DIABLO CANYON NUCLEAR PROJECT  
JOB # 7177  
SPEC # 8711

QUALITY ASSURANCE REPORT

Crack in Steam Generator Feedwater  
Nozzle to pipe weld  
(Generator No. 1-2)

## DISCREPANCY REPORT

DR 3366 Rev. I  
 ATTACHMENT # 2

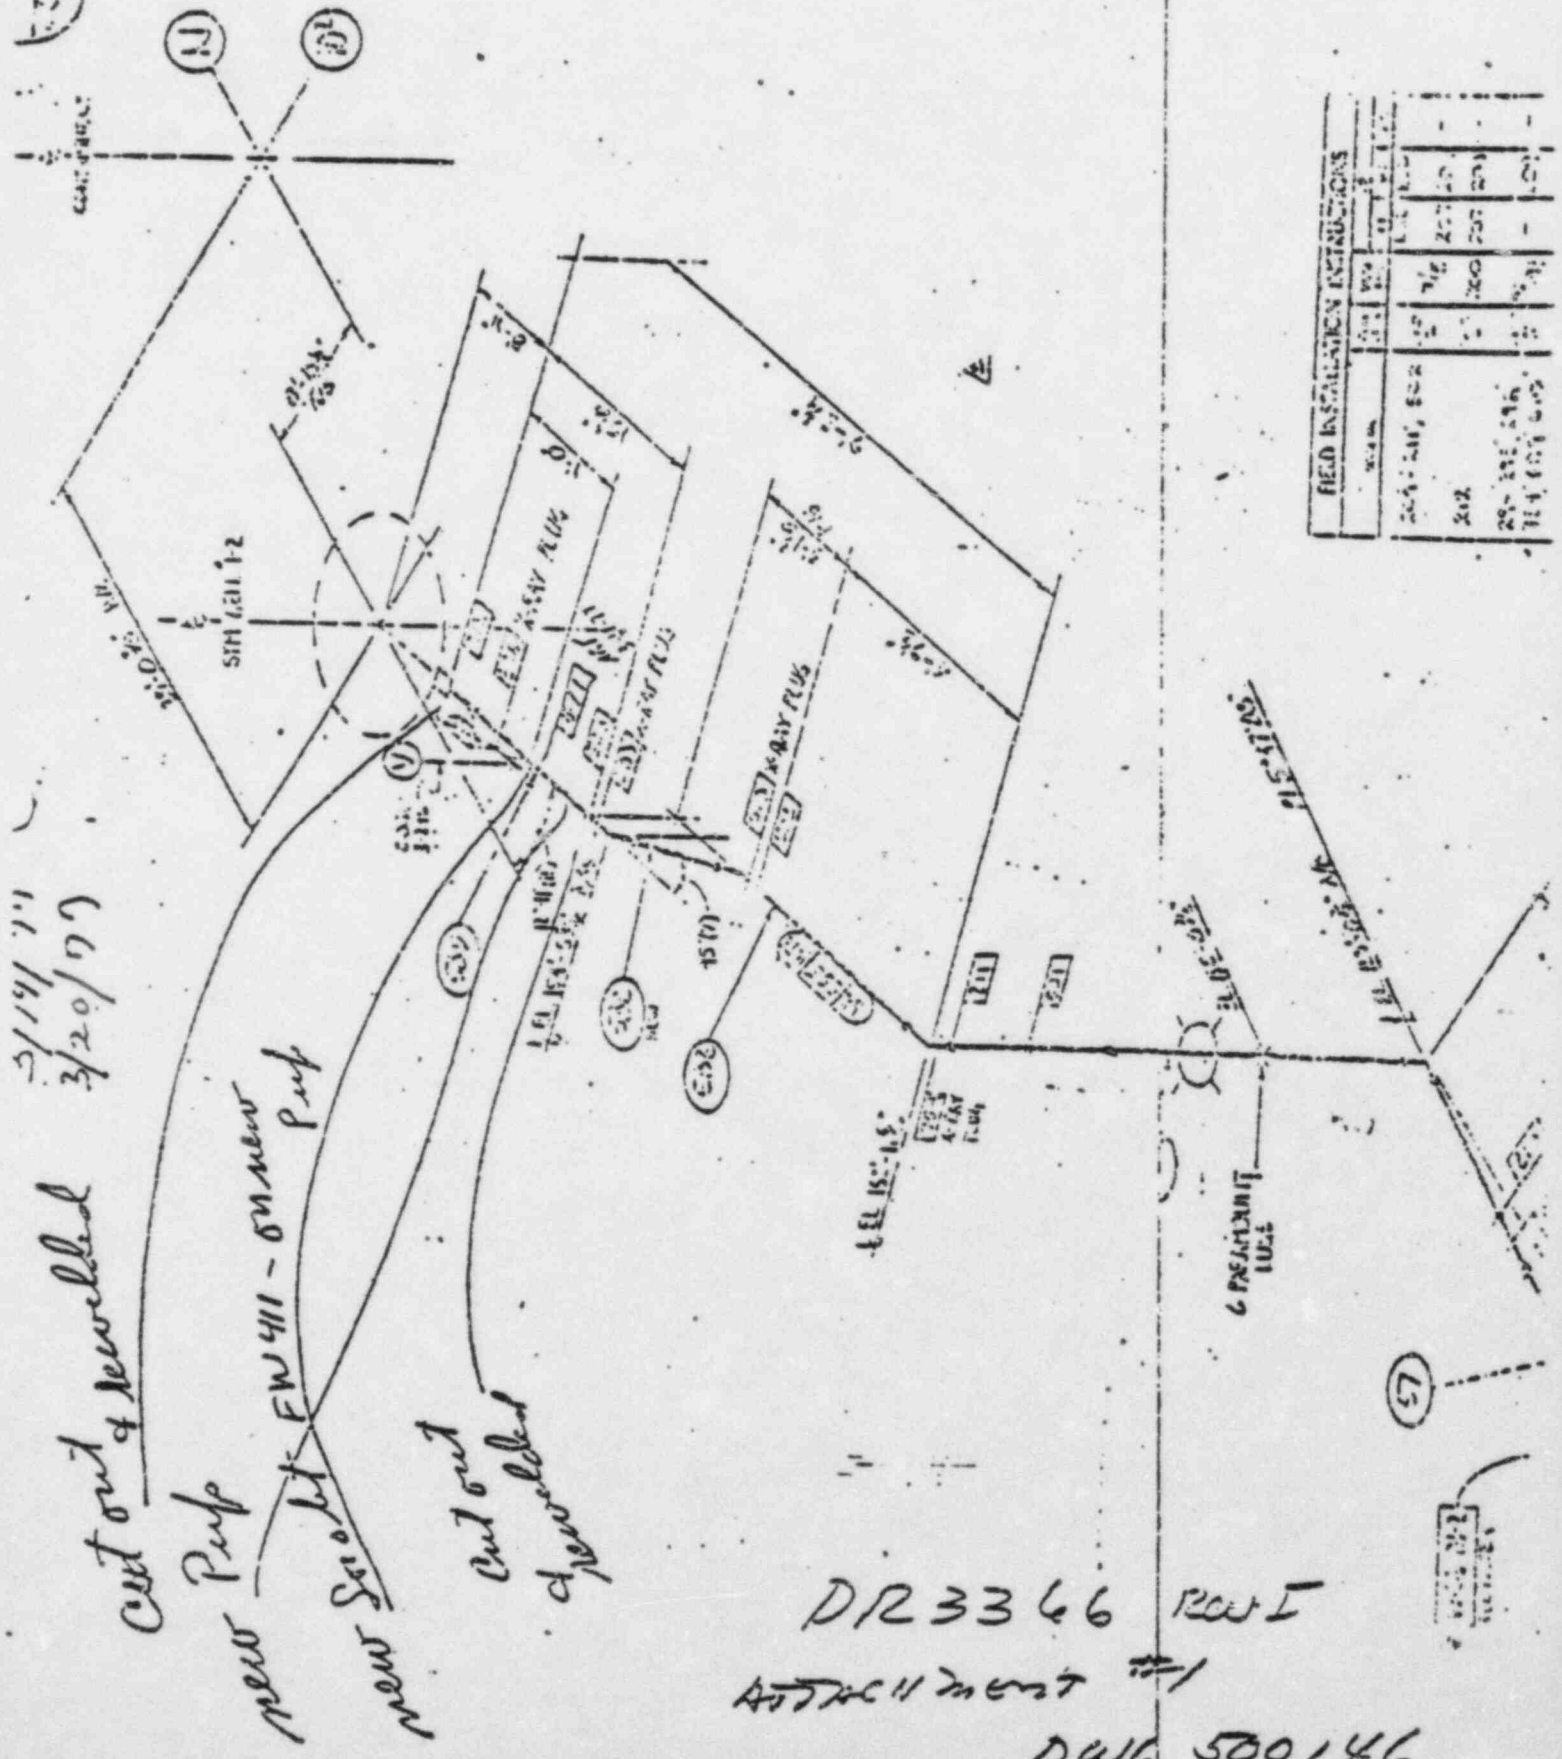
4. Drill and tap X-ray port in new spool. Install X-ray plug using seal weld F.W. #298.
5. Add all information to Iso and Process Sheets.

1. Preheat to 250°F minimum.
2. Maintain interpass at 250°F minimum, 500°F maximum until weld is complete and post weld heat treatment begins.
3. M.T. root pass; ESD-250.
4. R.T. after root and 2 layers weld added ESD-207. Repair if required and re-R.T. before completing weld.
5. Post weld heat treat at 1100°F minimum, 1150° maximum hold for 1 hour minimum, AT temperature..
6. Following post weld heat treatment, perform R.T.; ESD-207 and M.T.; ESD-209.
7. P.G.&E. will perform U.T. of final weld and maintain records.

Change para B , sub I to read "U.T. of weld performed by P.G.& E. personnel".

Add line 8 to additional Requirements. " M.W.Kellogg will perform U.T. of final weld and incorporate results into Iso package".

DWG 500146

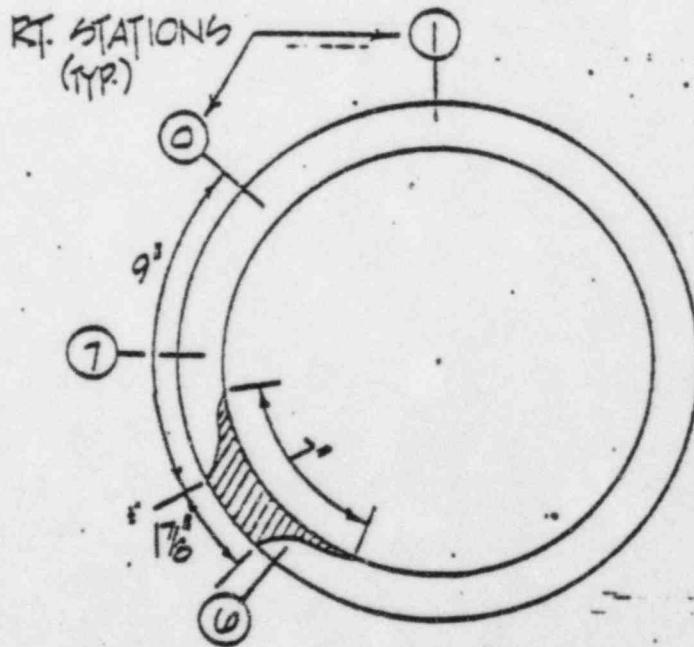
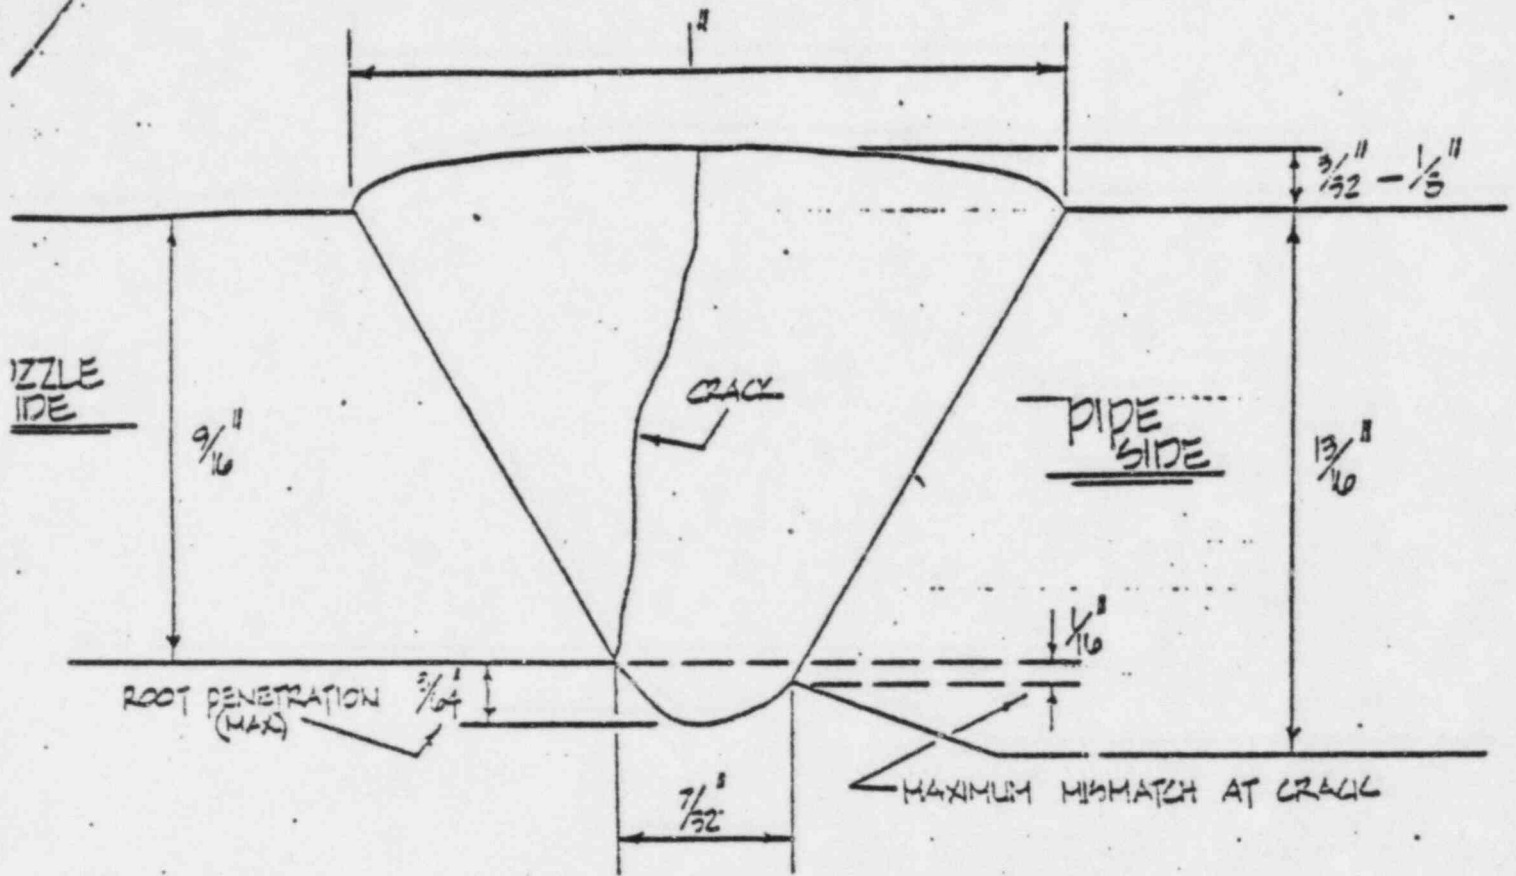
Cut out & reworked

new Sewer pt. FW 411 - on new Pump

Cut out & reworked

(JOINT DETAIL)  
FOR RE-WELD  
OF FW 212

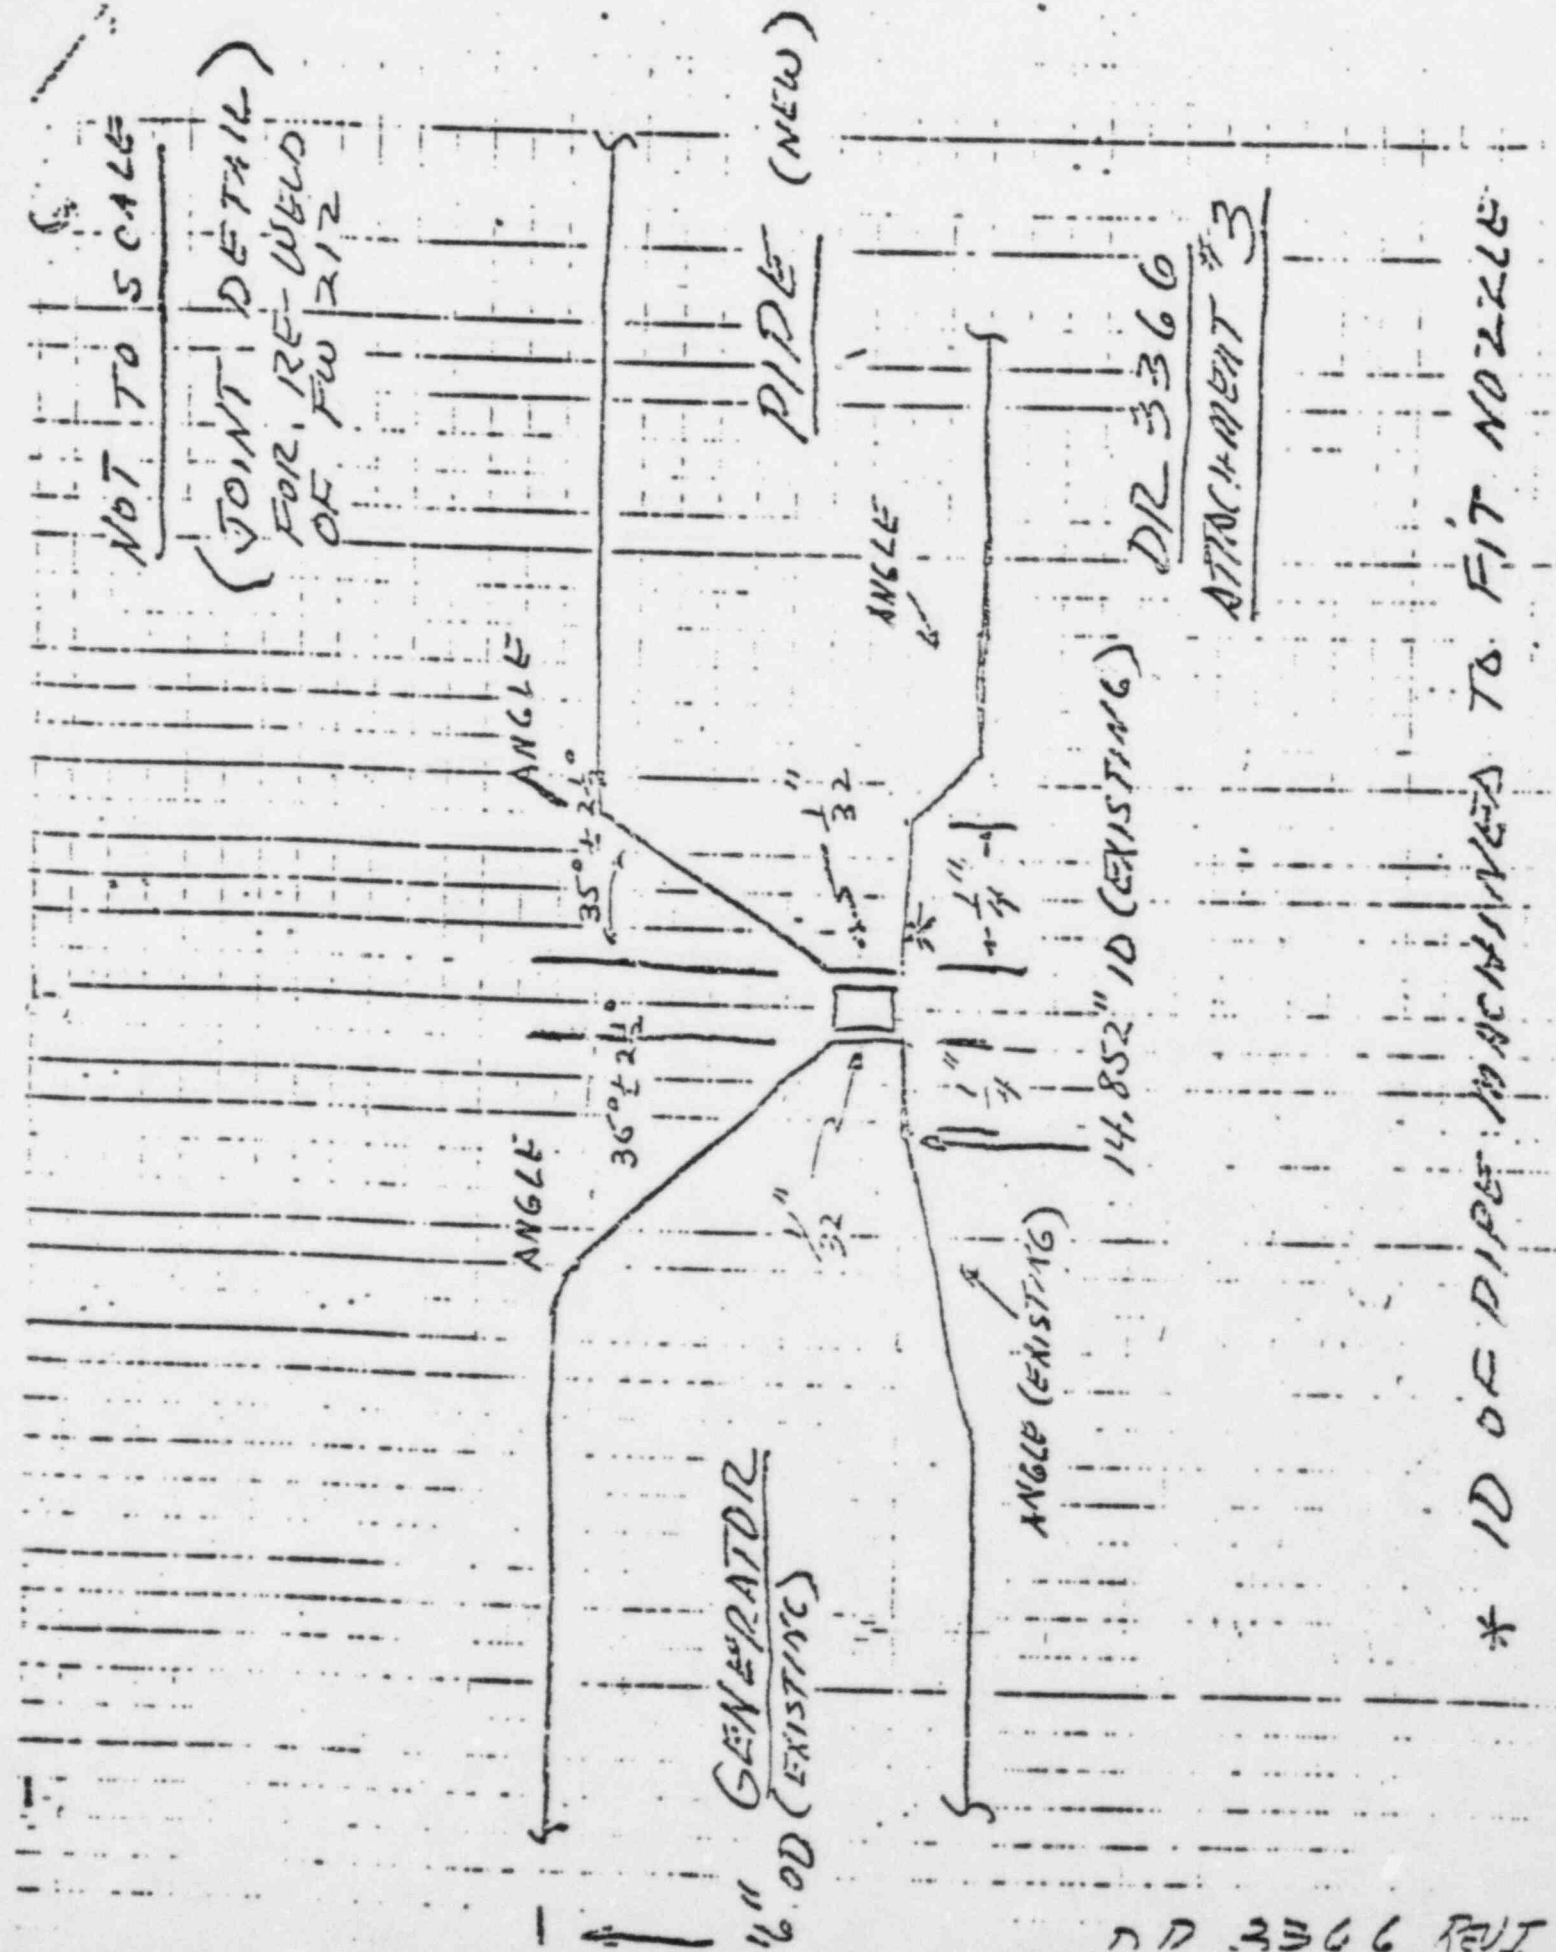
\* ID OF PIPE IS ANCHORED TO FIT NOZZLE

SECTION THRU PIPE NEAR F.W. 197

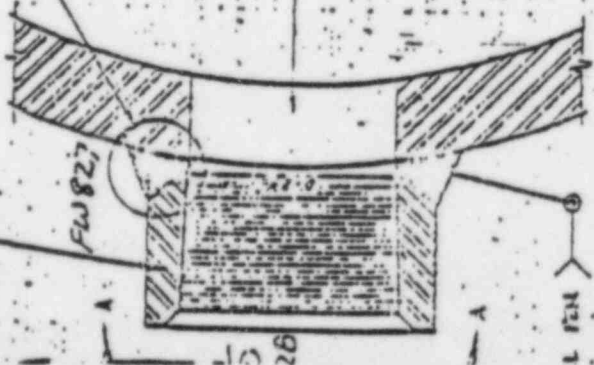
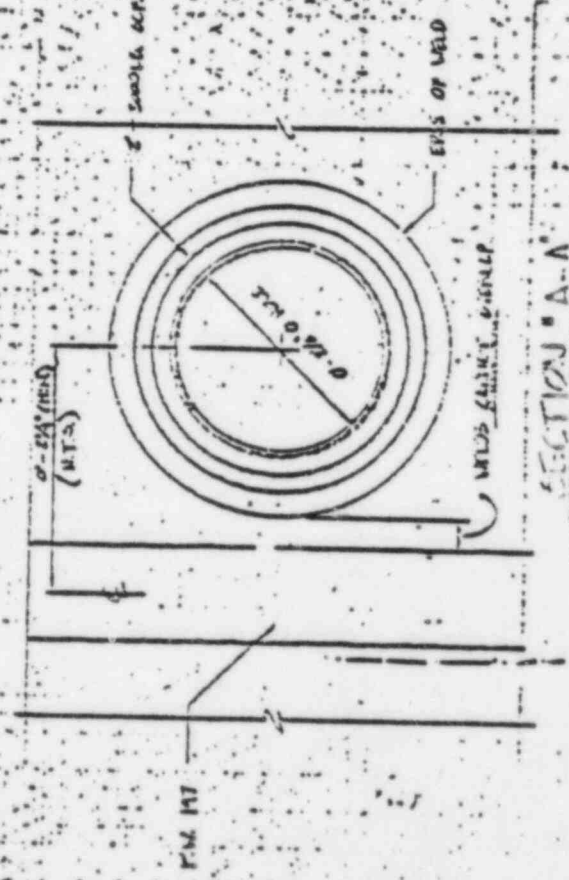
CUT 2 1/2" Ø WALL WITH 5/16" SAW AFTER WELD.

- WELD ON 2" - SMOOTH DEFORMED COUPLER INTO COUPLER
- CUT THRU PIPE WALL WITH 2 1/2" Ø WALL SAW
- GRIND OUT I.D. OF F.W. 197
